IN THE MATTER OF Newfoundland and Labrador Hydro's Reliability and Supply Adequacy Study.

Requests for Information

by the Labrador Interconnected Group

LAB-NLH-029 to LAB-NLH-054

Chart 7: Forecast Shortfall on a Typical Peak Day with the LIL Unavailable (January 2026)

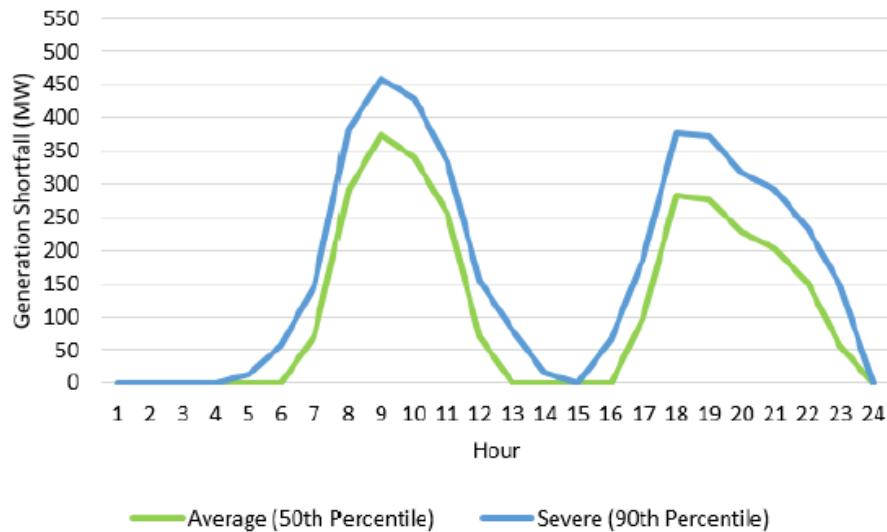
Please provide a similar table showing shortfall as a percentage of load.
